Landscape Response

In respect of a Clarification of Additional Information

UNIT 1 M50 (planning ref. SD22A/0460)

By Macro Works

Figure Error! No text of specified style in document..2: Areas of the site included for Green Infrastructure measures (Dark Green = Retention of existing vegetation and grassland, bolstering/enhancement of existing vegetation, Light Green = Permeable Paving)

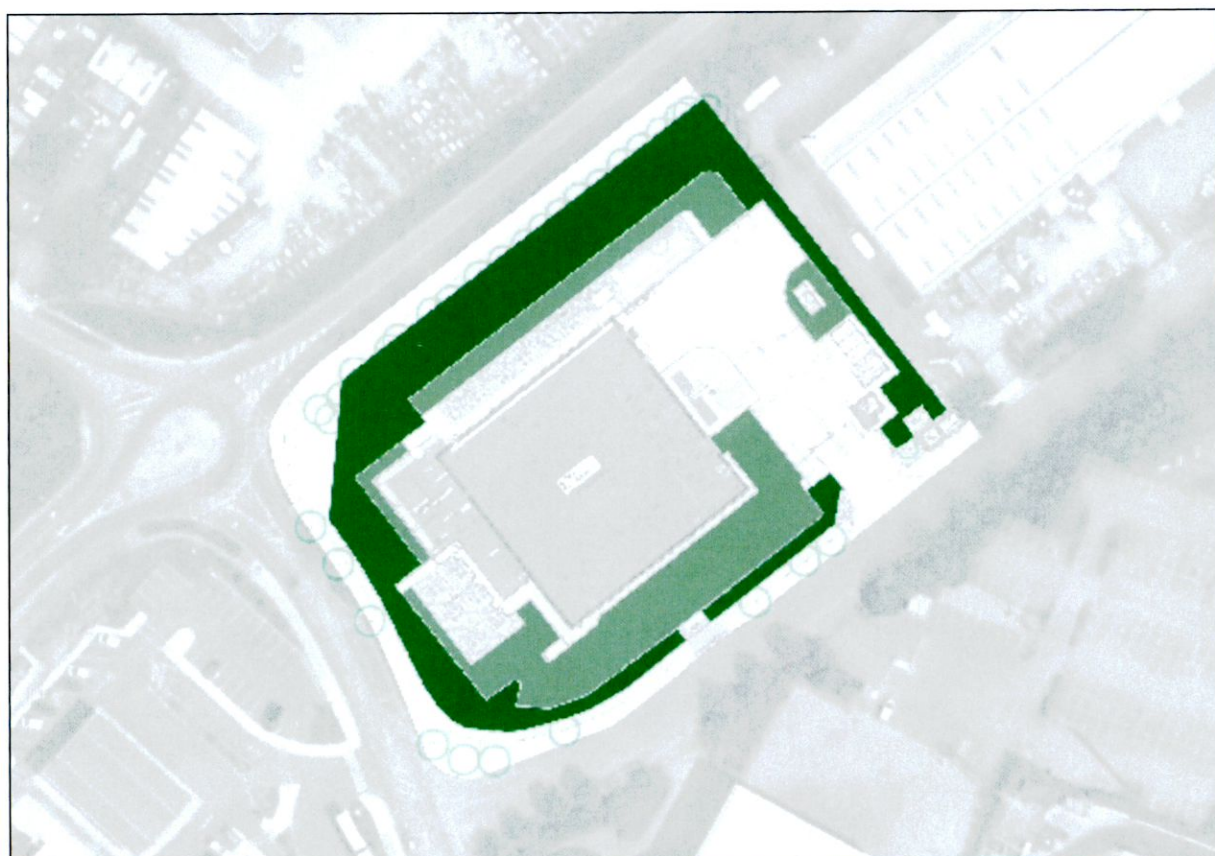
In this instance, the site's zoning (EE) requires a GSF of 0.5. As part of the request for further information, the proposed development achieved a score of 0.34. Nonetheless, prior to engagement with South Dublin County Council (SDCC) on the Green Space Factor tool, an updated score of 0.44 was generated on the basis of the layering technique outlined by SDCC and the additional green infrastructure interventions that were proposed, which included pollinator friendly bulb planting, a proposed rain garden and an additional green roof system over the existing security hut (see figure 3 below).

In terms of green infrastructure interventions within the proposed development site, up to 43.6% of the site areas will be retained/utilised for green infrastructure measures (see figure 2 below). This can be broken down in to the following areas;

- 25.48% - Green Infrastructure Measures 1 – Retention of areas of existing vegetation, bolstering and enhancement of planted areas with additional native pollinator friendly stock, retention of grassed areas and seeding of drifts of native pollinator friendly wild grass seeding of local provenance.
- 18.14% - Green Infrastructure Measures 2 – Permeable Green Infrastructure: Permeable paving in car parking areas and at surrounding building access.
